City of Avondale Estates
Planning Architectural Zoning Board
Staff Review, Variances *

November 17, 2025, PAZB Meeting

Applicant: 278 Oak Holdings LLC: Jetha Wagner, Avila Development

Property Address: 136 Laredo Drive, 2968 Parry Street, 147 Oak Street, 2950 Franklin Street, and 2556 Franklin Street (Oak Parcel)

G)

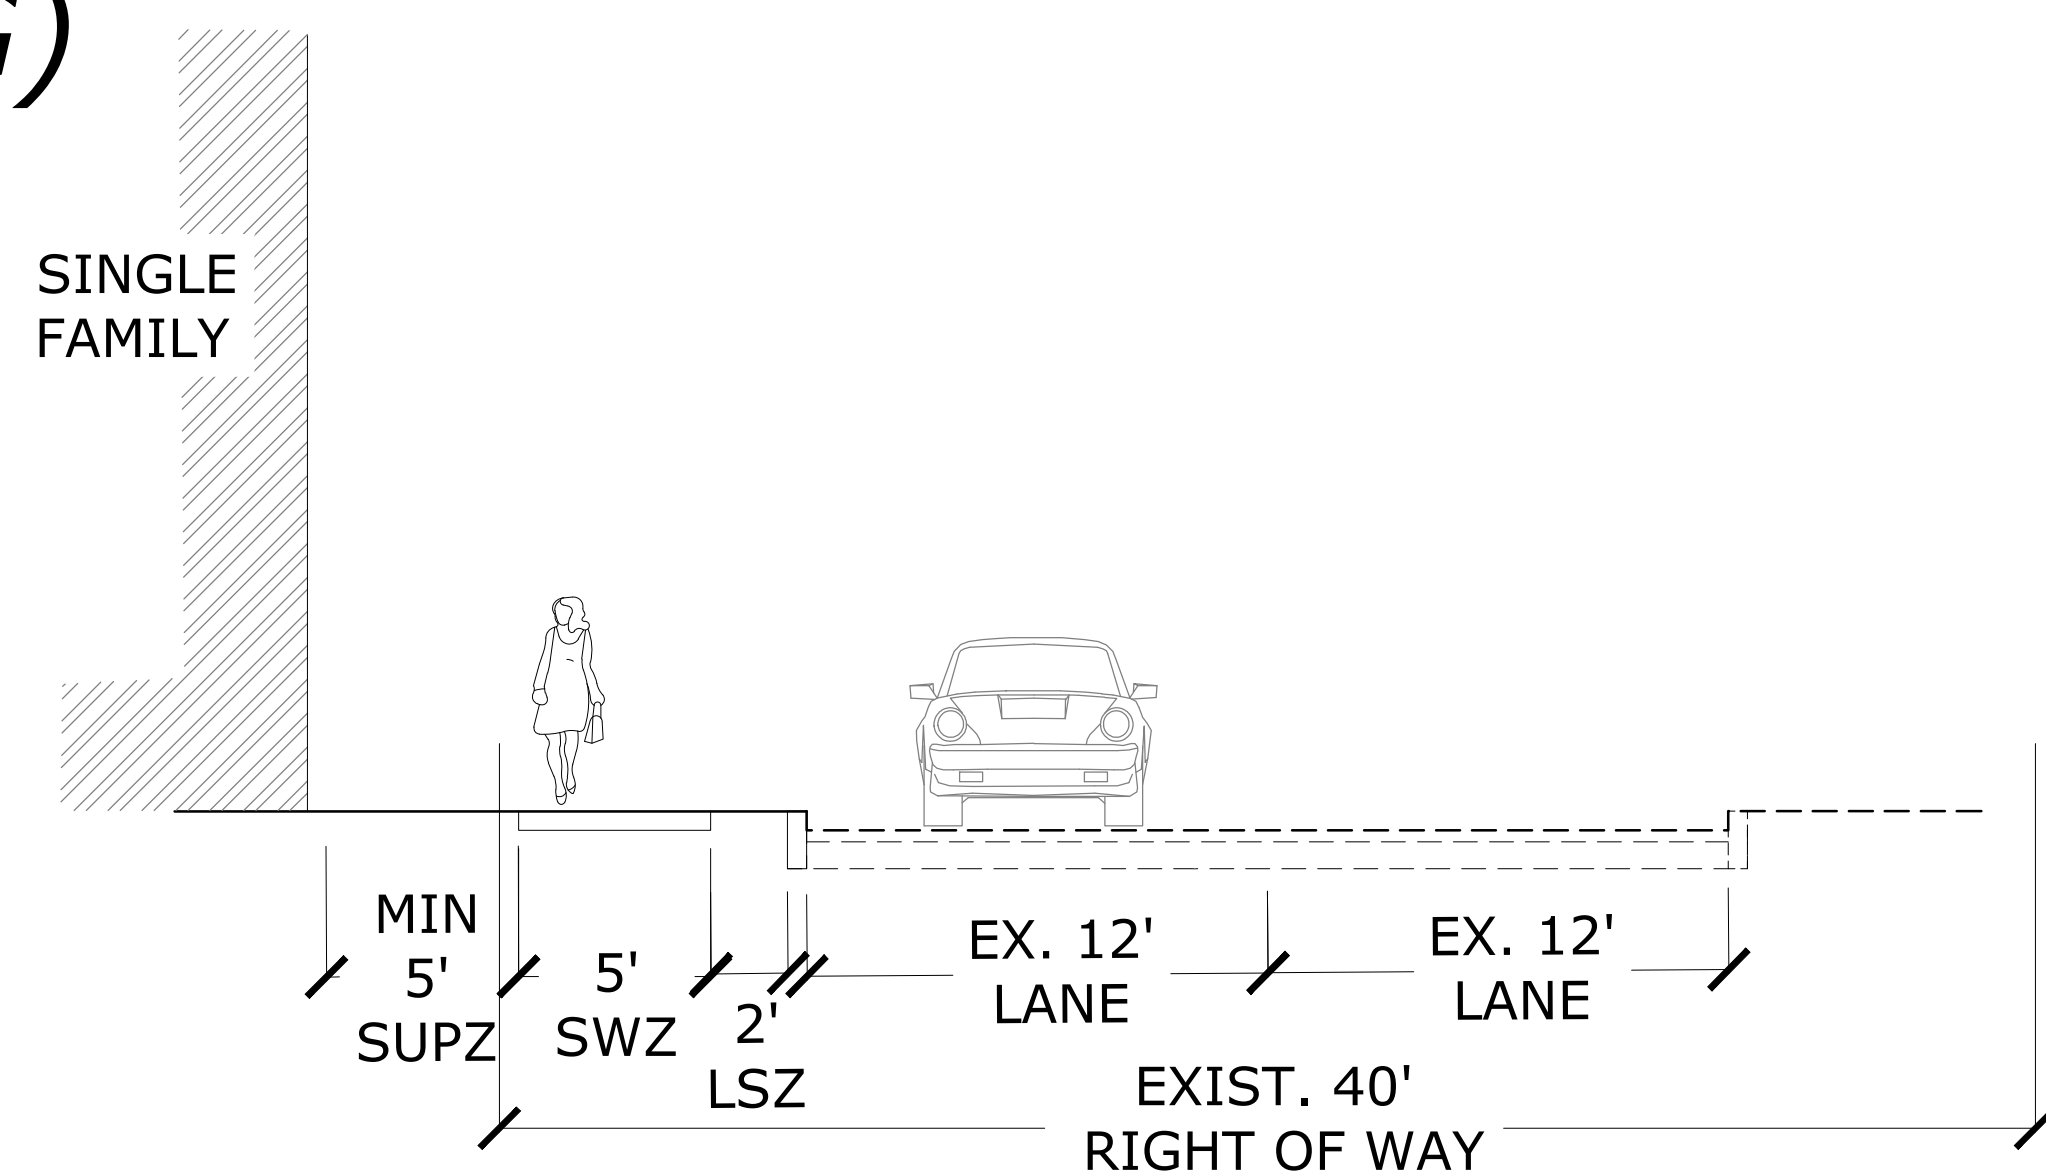
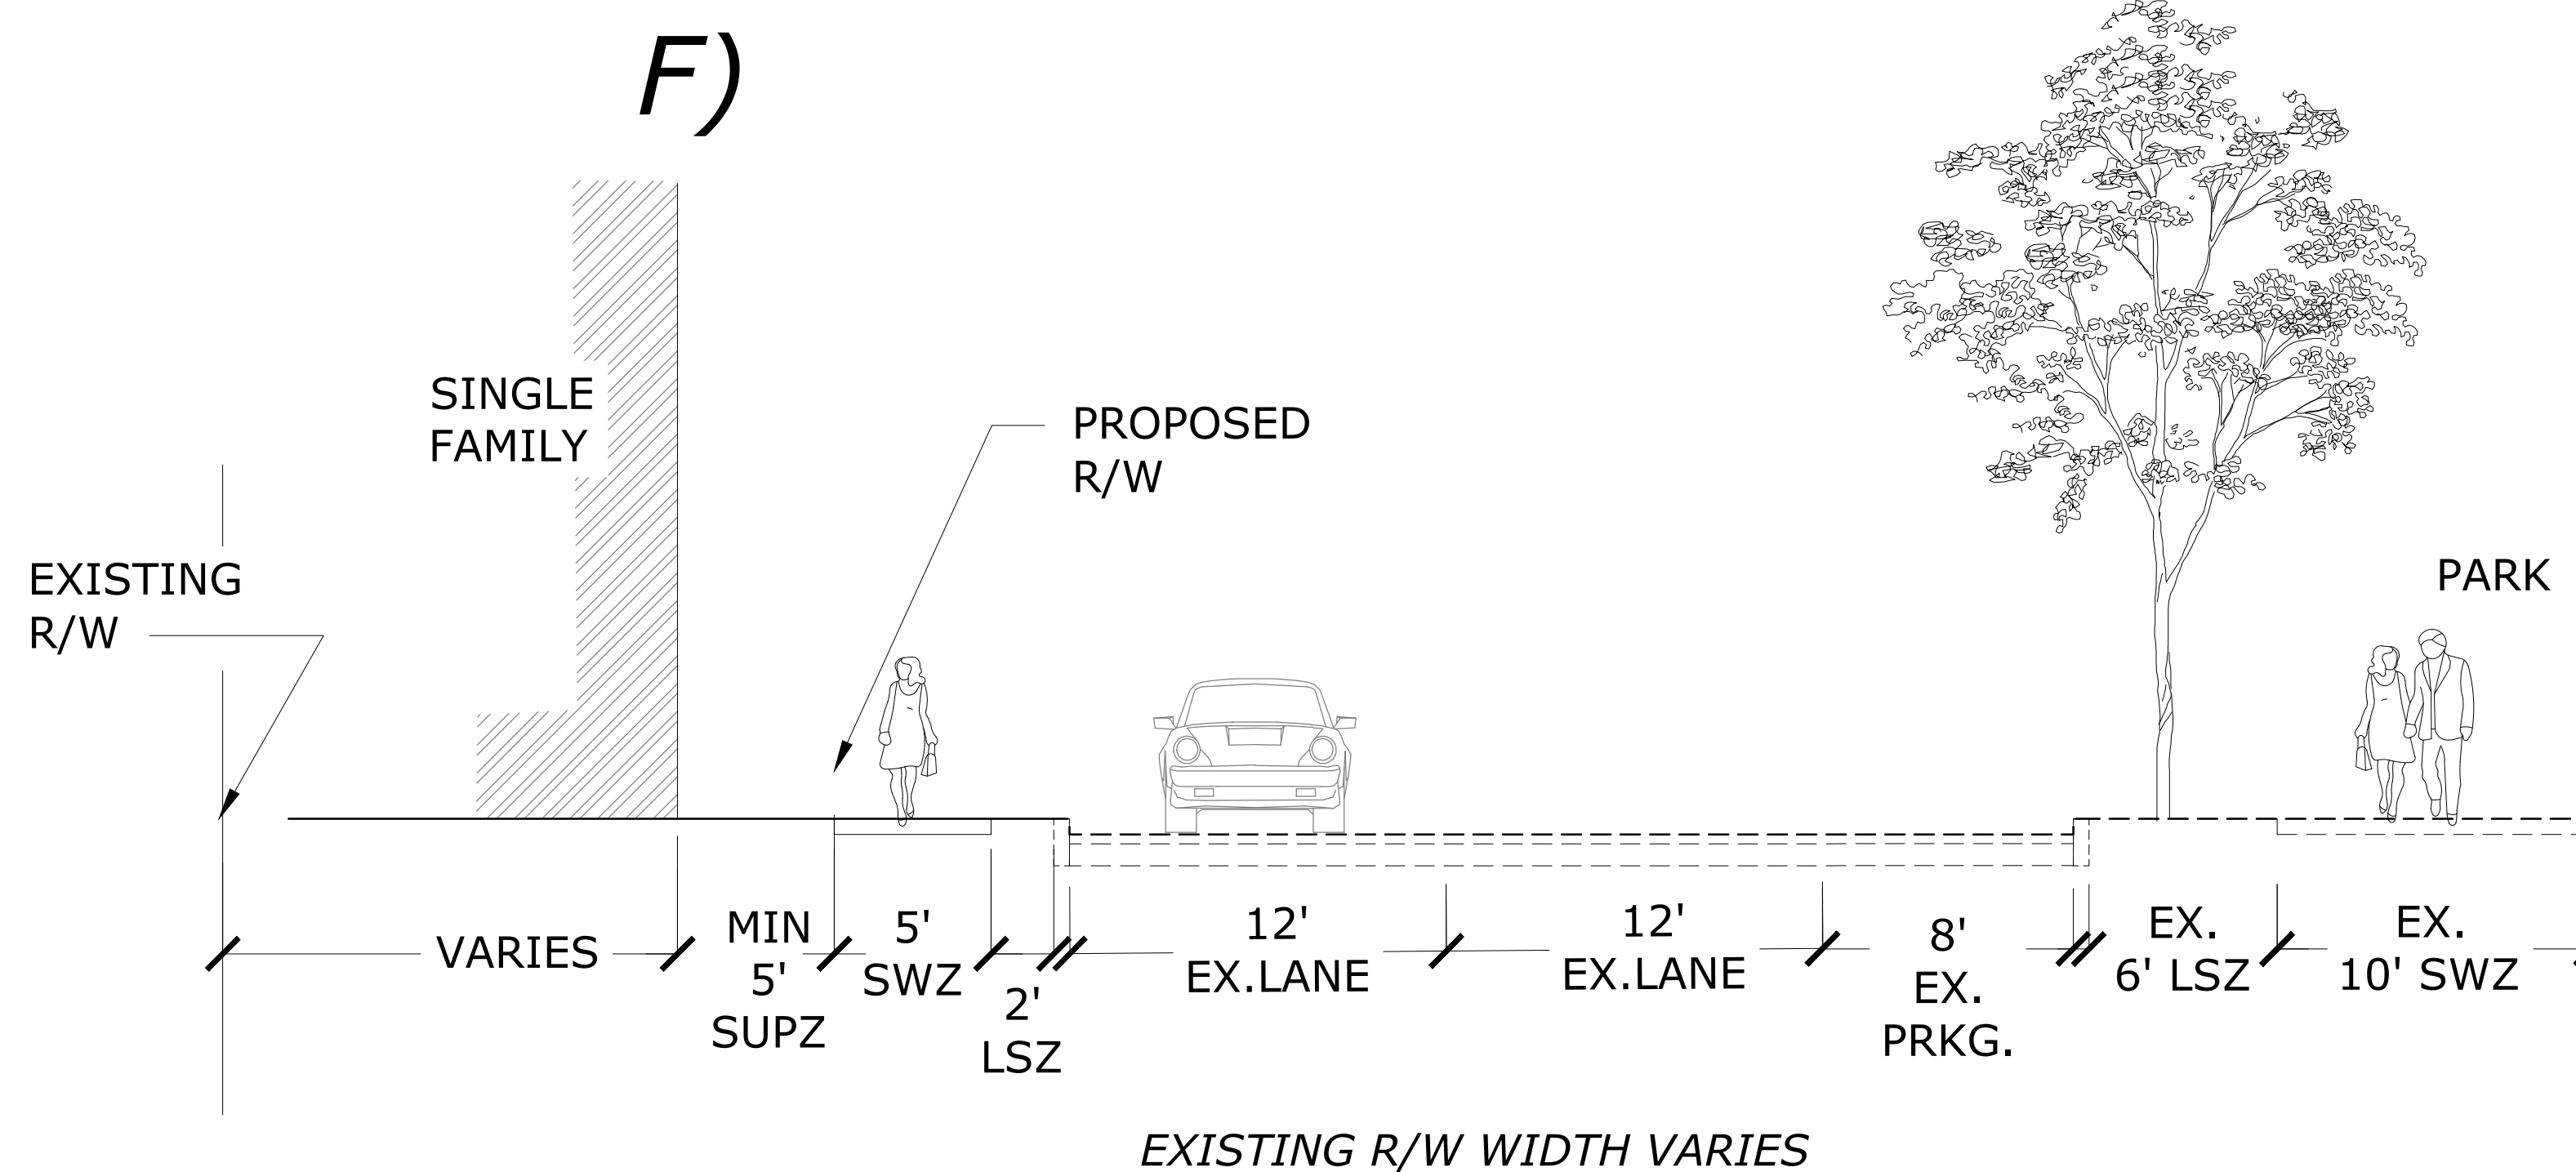
FROM: Figure 21-3.2.8.B.4.b and Table 3.2.8.E reduce type B2 street section from 60' ROW and 5' SUPZ to building face.

FROM: Figure 21-3.2.8.B.4.b and Table 3.2.8.E reduce type B3 street section from 45' ROW, 3 LSZ and 5' SUPZ to building face.

FROM: Figure 21-3.2.8.B.4.c and Table 3.2.8.E reduce type C1 street section from 55' ROW and 5' SUPZ to building face.

FROM: Figure 21-3.2.8.B.4.c and Table 3.2.8.E reduce type C2 street section from 40' ROW and 5' SUPZ to building face.

FROM: Figure 21-3.2.8.B.4.c and Table 3.2.8.E reduce type C1 street section from 55' ROW and 5' SUPZ to building face.

FROM: Figure 21-3.2.8.B.4.b and Table 3.2.8.E reduce type B1 street section from 72' ROW and 5' SUPZ to building face.

FROM: Figure 21-3.2.8.B.4.d and Table 3.2.8.E reduce type D street section from 40' ROW and 5' SUPZ to building face.

Figure 3.2.12.F - Transitional Height Plane

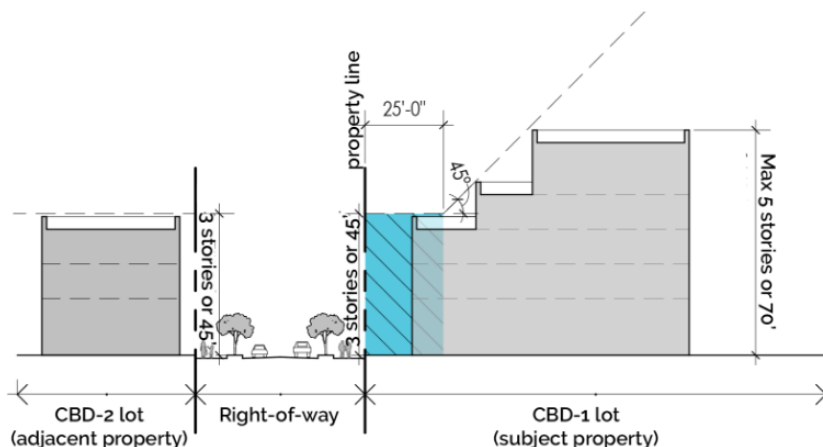
DESIGN TEAM NOTE: This requirement impacts the Southeastern corner of the Maple Street site, which abuts the CBD-2 district across Olive Street. This would limit that portion of the building to 3-stories (instead of 5) which could eventually step up to 5-stories. See Figure 3.2.12.F below. Need to be allowed 5-stories (plus basement) in all locations – including areas where transitional height plan comes into play.
